HGY/2024/0921 Harcourt House Roof Extension

Objection to Planning Application, incl Latest Amendments to the Drawings and Reports as of 7th March, 2025

Planning Application HGY/2024/0921 Erection of one additional storey at roof level to existing building to provide two self contained apartments, plant and associated works

Extract from submitted elevation CF-214-DR-1310-B

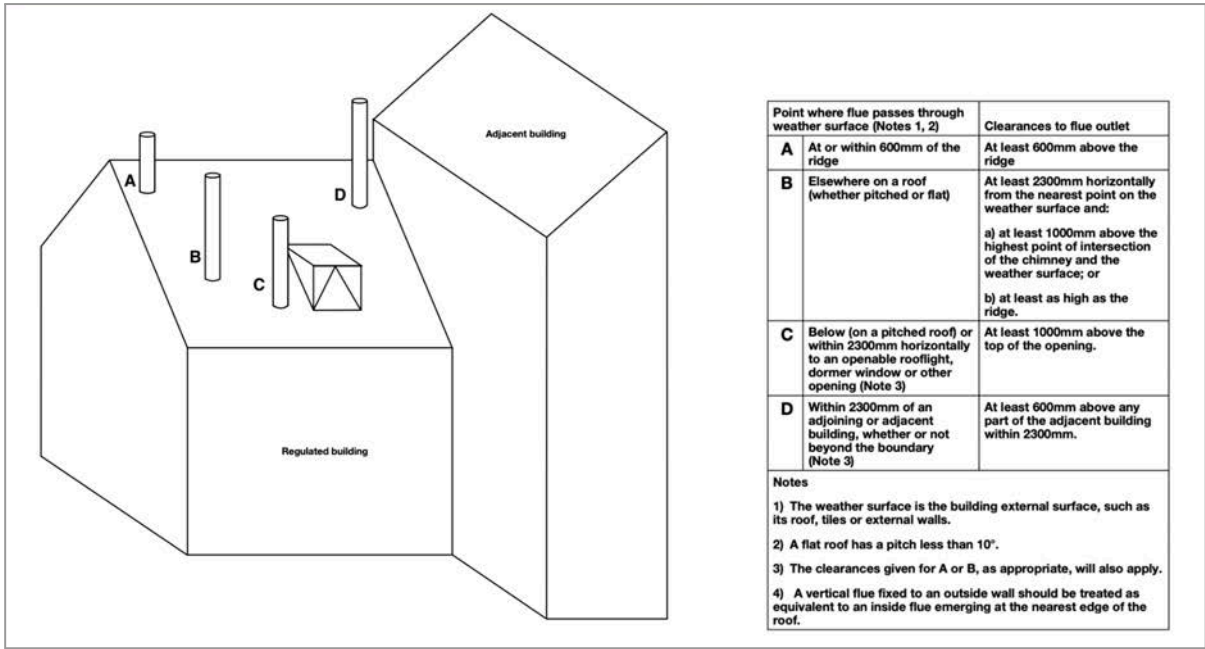
- 1.2. **Unfeasible design of chimney flues; unfeasible position and proximity of new walls, roof and openings adjacent to active flue openings.** The East elevation of the new structure is designed to be approximately 1m distance horizontally from the openings of heightened stack of flues on the party wall shared between 17 and 18 Haringey Park. This design is flawed and infeasible as it contravenes Building Regulations 2010 AD Part J (Combustion Appliances and fuel storage systems). Section J2 of the document mandates the requirements for discharge of products of combustion. For illustration, Diagram 17, on page 31¹ explains that clearances to flue outlets must be “at least 600mm above any part of the adjacent building within 2300mm”. This is to ensure the safety of those using the flues as well as the safety of residents in the proposed new flats. As residents we can confirm categorically that the flues are in use. Therefore, the current design is unquestionably unfeasible with current information and must be amended to meet regulations. This must be done before determination as the necessarily amended design will have potential impact to the height of the flues, the position of the proposed new opening (window) in front of the active flues as well as possibility of moving the walls and the roof to positions compliant with safety regulation.

Extract from submitted elevation CF-214-DR-1220-B

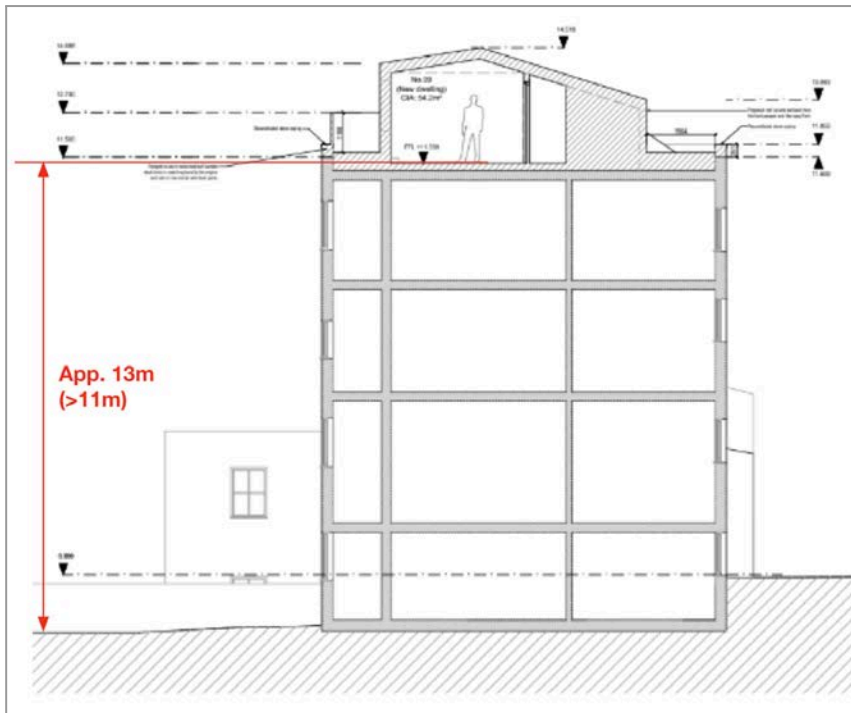
1.3. **Unfeasible design through non compliance with fire safety.** The floor level of the new flats will be more than 11m above ground level of the lowest part of the building and the building will contain more than 4 stories (see diagrams below). This requires ‘building-wide’ changes to meet the Building Safety Act 2022, enacted following the Grenfell Fire. Sprinklers, smoke vents and protected fire lobbies will be required to meet the latest Building Regulations AD Part B1. The current design, fails to recognise this unambiguous categorisation of the building and makes no provision for the additional fire safety measures. These measures, when adequately designed and implemented, will have material impact to the appearance and internal layout of the existing and proposed flats.

Extract from submitted section CF-214-DR-1220-B

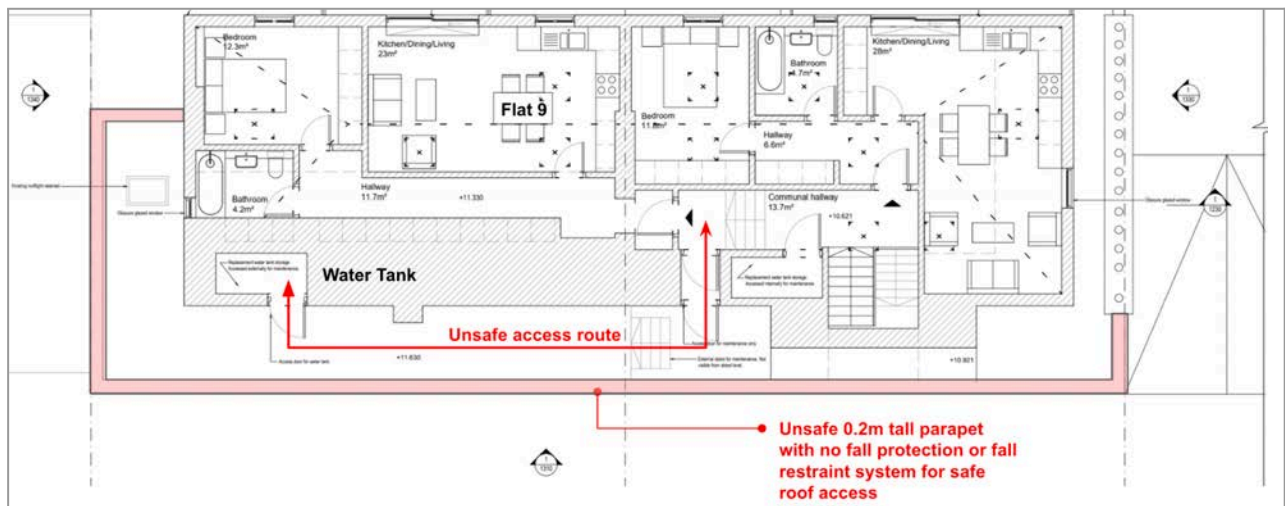
- 1.5.3. **Smoke vent** - An automatic smoke vent is required at the top of the stairs to meet Building Regulations AD Part B1. Smoke vents are not discrete, cannot be flush mounted and will therefore impact the appearance of the proposed roof extension. See below for an example of a smoke Automatically Operated Vent (AOV). The proposed drawings must be updated to show the AOV accurately so that the visual impact can be assessed. Complete lack of any features and systems required for fire safety of buildings over 4 storeys and over 11m high makes the proposed design unfeasible and must be addressed before determination.

Extract from submitted plan CF-214-DR-1130-B (above) and Extract from submitted section CF-214-DR-1210-B (below)

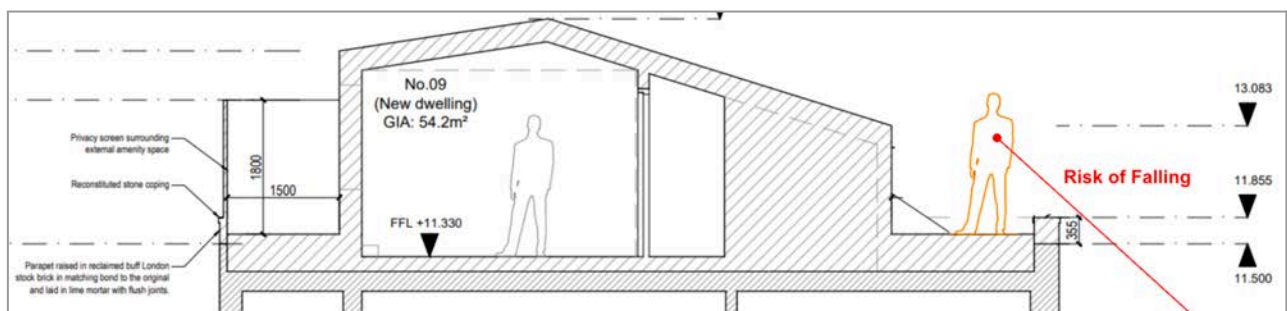
- 1.6. The proposed location for the water tank behind Flat 9 presents significant safety concerns. Accessing the relocated tank requires traversing a narrow, approximately 1-metre wide walkway without any edge protection. This configuration contravenes both Health & Safety legislation for working at height and Building Regulations AD Part K, which mandate the provision of safeguards to prevent falls and ensure safe access for maintenance and inspection. The safety is further exacerbated by 1m tall openings and access issues outlined in paragraph 4.2.1. The current design is unfeasible and can not be mitigated by a simplistic statement in the drawings that the access will be reserved to “qualified personnel only”. It is imperative that the applicant incorporates appropriate edge protection and depicts them in the planning drawings and visualisations so its visual impact can be understood and evaluated.

Extract from submitted plan CF-214-DR-1130-B and flank elevation CF-214-DR-1330-B

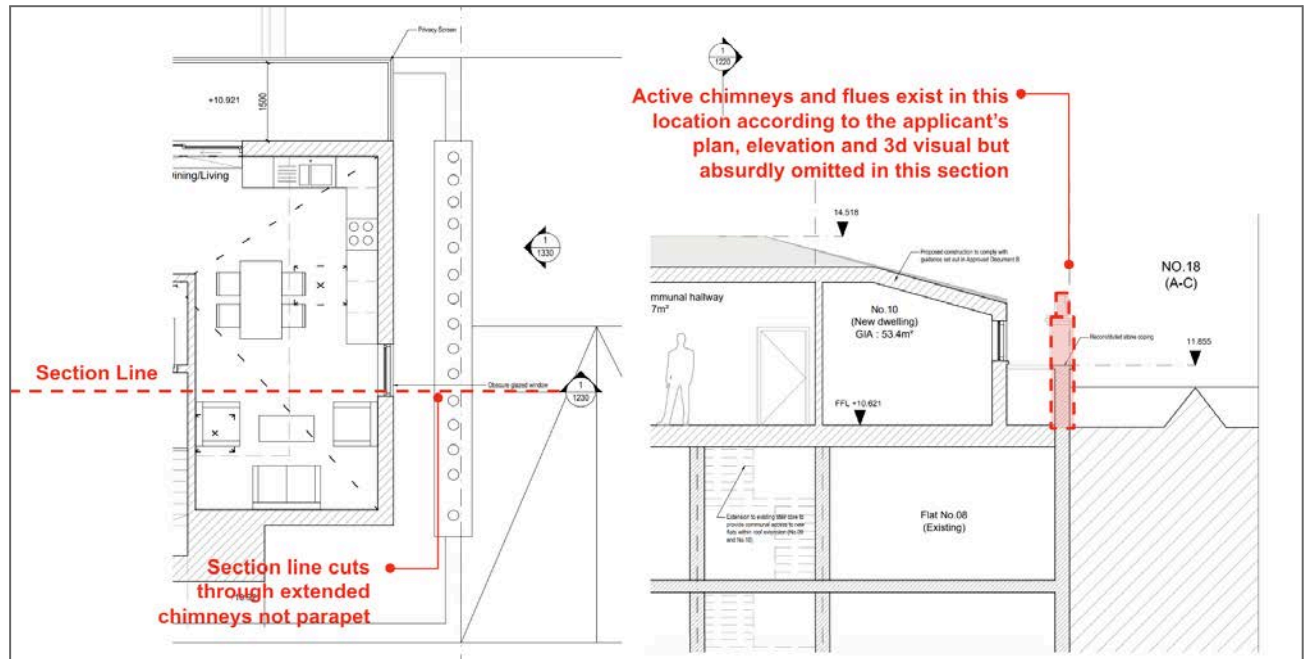
- 2.3. The applicant's Design & Access Statement claims that the proposed new flats will be dual aspect. This is incorrect - For Flat 10, the proposed rooflights do not qualify as an aspect. Additionally, the obscured side window from the kitchen does not meet the requirements for an aspect, as the distance between this window and the opposing wall is substantially smaller than the width of the wall. This is illustrated in the applicant's submitted markup of the plan, elevation, and 3D visuals.

Extract from submitted plan CF-214-DR-1130-B and section CC CF-214-DR-1230-A

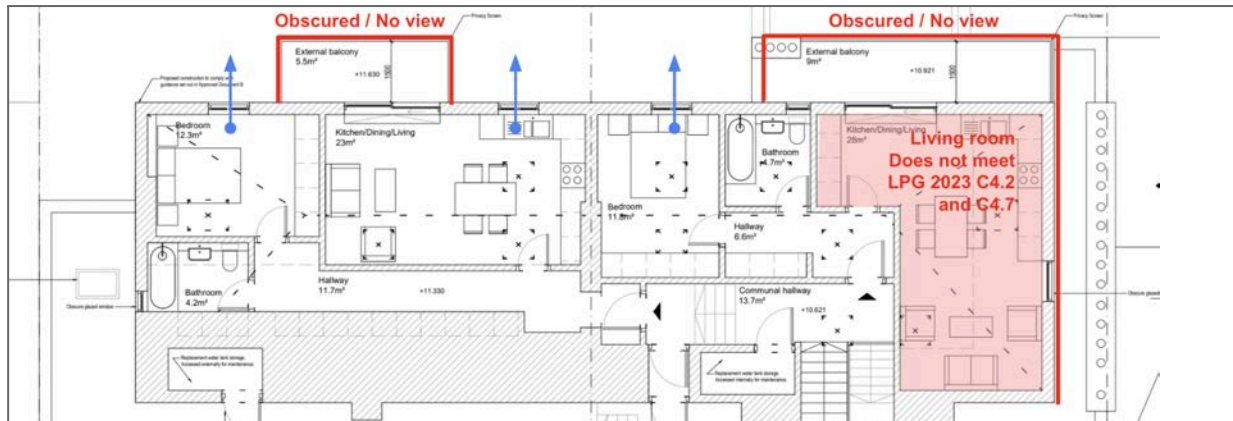
- 2.4. The applicant's new proposed Section CC (CF-214-DR-1230-A) is **false**, and contradicts the submitted plan and flank elevation. The flank elevation and plan above shows that the living / kitchen window for Flat 10 is behind / obstructed by the chimney flues. However, the chimneys are inexplicably removed from Section CC. This discrepancy is disingenuous, misleading, and unprofessional. The section must be updated and resubmitted to accurately reflect the relationship between the side window and the chimneys. **Once the section is updated, it will be evident that Flat 10 is a single aspect north facing unit which is not allowed in the London Plan 2021. For Flat 9, all habitable rooms will also be single aspect north facing as the only window not facing North will be in the restricted height WC.**

Extract from submitted plan CF-214-DR-1130-B

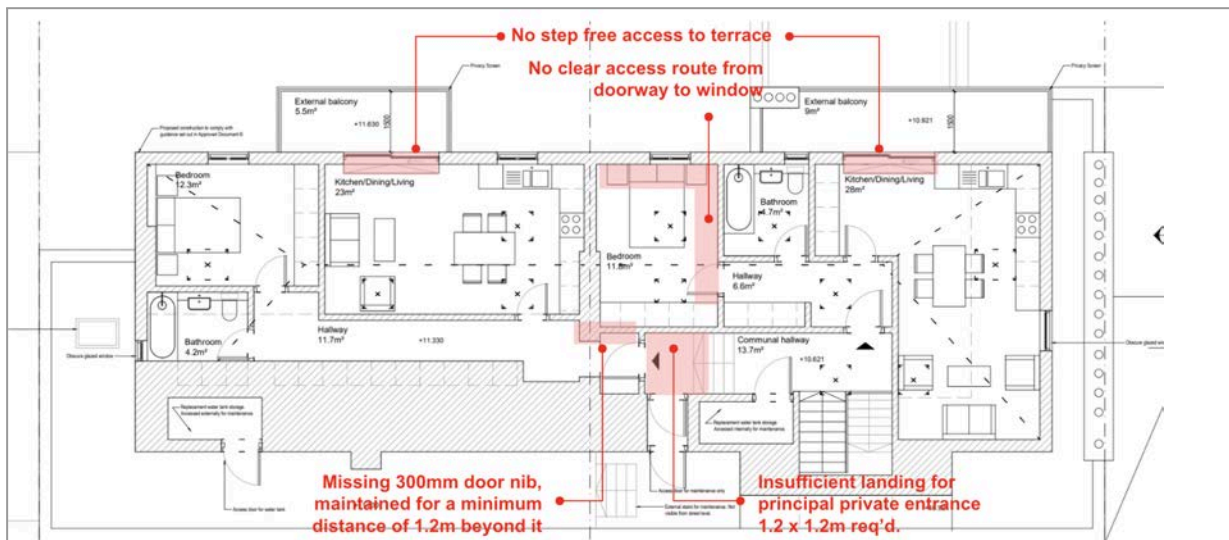
- 2.6. The revised plan (CF-214-DR-1130-B) shows that nearly all rooms will lack a view due to obscured side windows and balconies enclosed by 1.8m tall privacy screens to minimise overlooking of neighbouring properties. **Specifically, Flat 10's living room will have no view and fails to meet LPG 2023 C4.2 and C4.7 requirements.** The design of these dwellings is completely compromised, will offer poor quality of accommodation for the residents and fail to meet standards the local authority and London Housing Design Standards set out and should not be permitted in their current form.

Extract from submitted plan CF-214-DR-1130-B

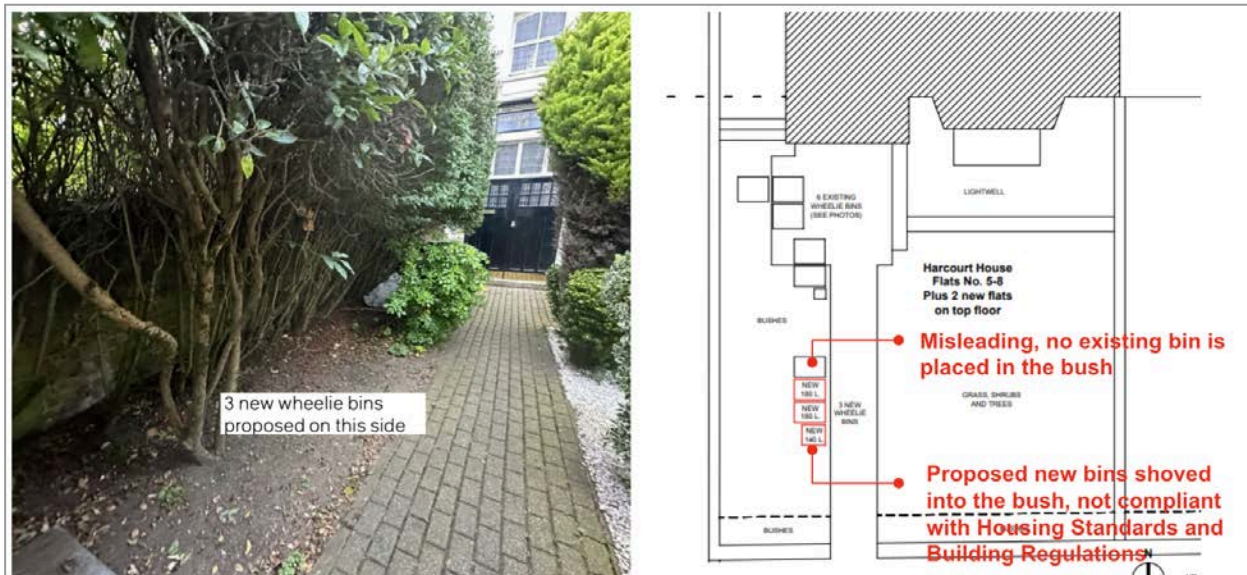
- 2.8. While the applicant confirmed compliance with AD Part M4(2) in their application form, they failed to provide any compliance evidence and supporting details as required by Haringey's planning application validation checklist for all applications involving new homes⁹. Based on the drawings submitted, **both new units are not compliant with AD Part M4(2), and London Plan 2021 Policy D7**. For example, both flats lack level access to private outdoor space¹⁰ and there is insufficient clearance for the principal private entrance¹¹, as illustrated in the markup below:

Extract from submitted plan CF-214-DR-1190-A

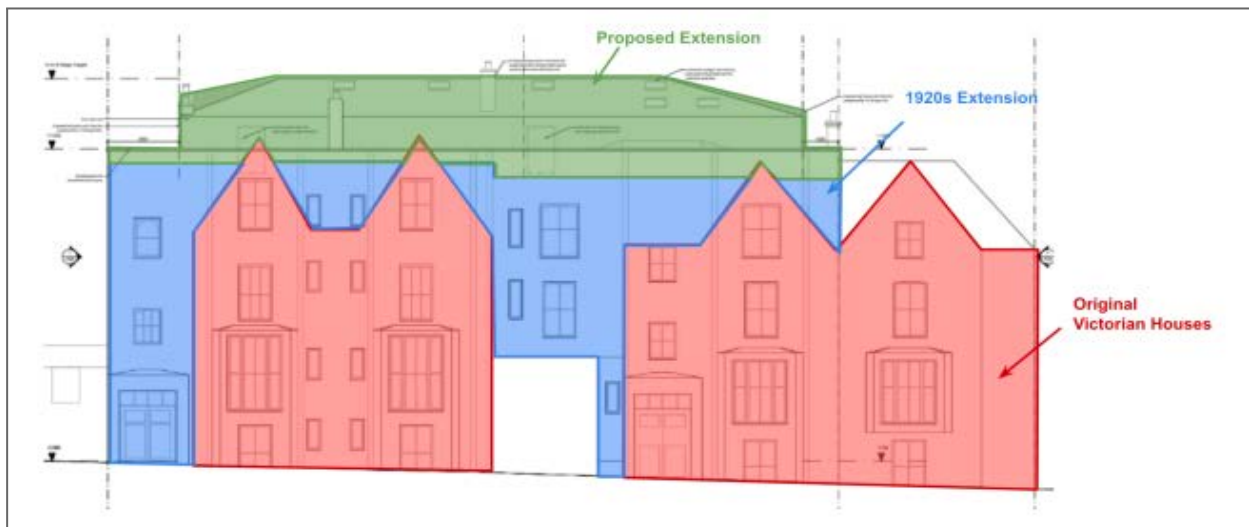
- 2.11. The applicant’s waste management proposal, as shown in the refuse and bike store plan and photo markup, is unacceptable. The suggestion that the new wheelie bins should be placed in the landscaped bush is unsightly, ill-conceived, and ridiculous. Residents will be greeted by a line of wheely bins before entering the building, and the bins will be directly visible from the habitable room windows of Flats 6 and 7. ***This waste proposal violates reasonable design standards, Housing Standards LPG, and Building Regulations AD Part H.***

Extract from submitted plan CF-214-DR-1140-B

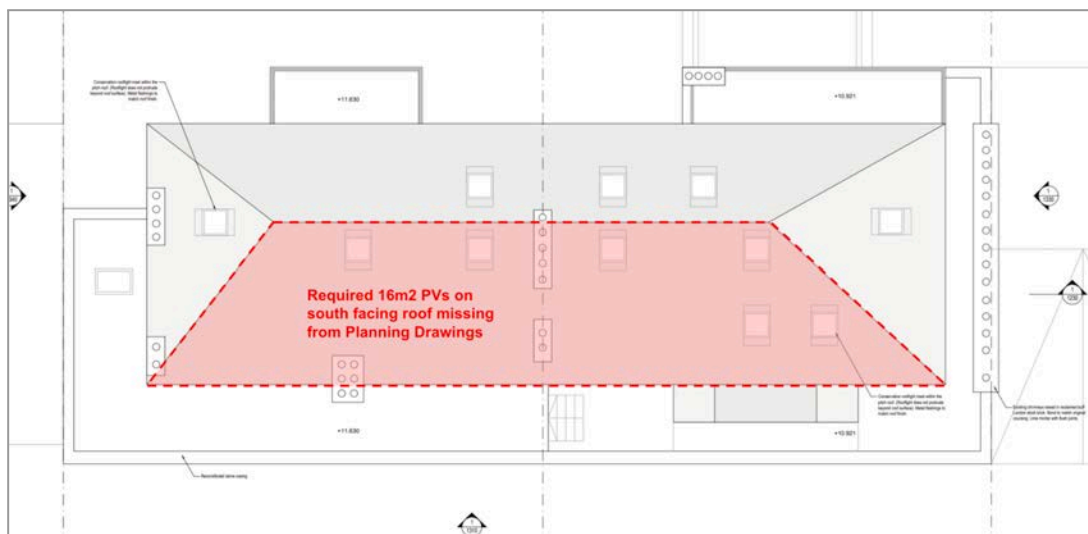
- 4.1. The applicant's Planning Energy Statement Rev 4 proposes installing 10 PV panels array covering 16.4m²¹⁴ on the roof of the extension to meet London Plan and Part L requirements. The Statement also recognises that the PV array may cause detriment to the character of the site and surrounding area. However, the revised planning drawings fail to show these required PVs. For PVs to be effective, they need to be oriented to face within 30 degrees from the south, as stated in the applicant's Energy Statement. For Harcourt House, this means the PVs will be installed on the sloping roof facing Haringey Park. The PVs will be visible from street level and incongruous with the character of the street and the conservation area. Furthermore, the required 16.4m² of the PV panels may obscure the skylights dotted around the south facing roof surface.

Extract from submitted plan CF-214-DR-1130-B

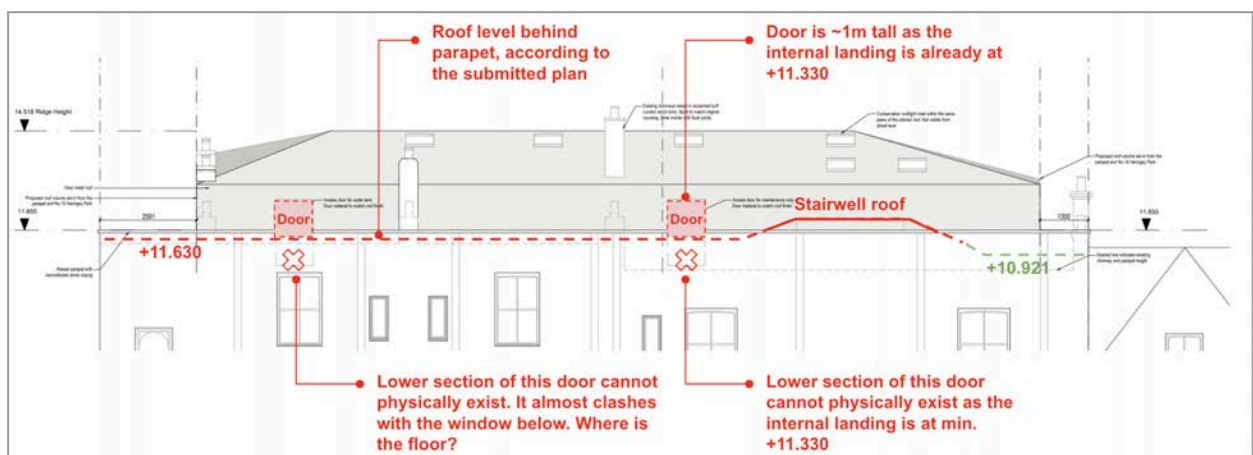
4.2.1. The doors accessing the roof and the water tank cannot physically exist as illustrated in the front elevation and plan extract below. According to the plan, the landing accessing the roof is already at a higher level (+11.330) therefore **both proposed access doors would only be 1 metre tall** which is absurd, unsafe and not compliant with regulations. It is incomprehensible that a qualified architect could overlook this when preparing the drawings. We are seriously considering reporting such failings in quality and professional standards to relevant registration and standards bodies.

Extract from submitted rear elevation CF-214-DR-1310-B

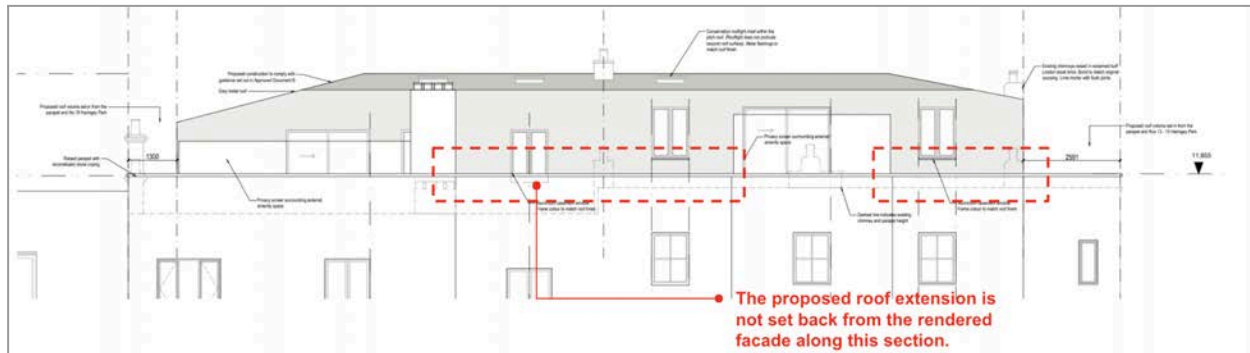
- 4.2.2. As mentioned in points 2.2 and 2.3 above, the new section submitted CF-214-DR-1230-A is taken through the side window of Flat 10 and contradicts the elevation drawing. The elevation CF-214-DR-1330-B shows the side window of Flat 10 is behind the chimney flues but the flues inexplicably vanish in the section. This is both wrong and misleading. The section must be updated to accurately depict the relationship between the side window and the chimney flues.
- 4.2.3. The rear elevation shows the proposed new window for Flat 10 is behind the new heightened rendered parapet. This is wrong and incorrect as the proposed metal extension is on the same plane as the rendered facade below according to the plans.
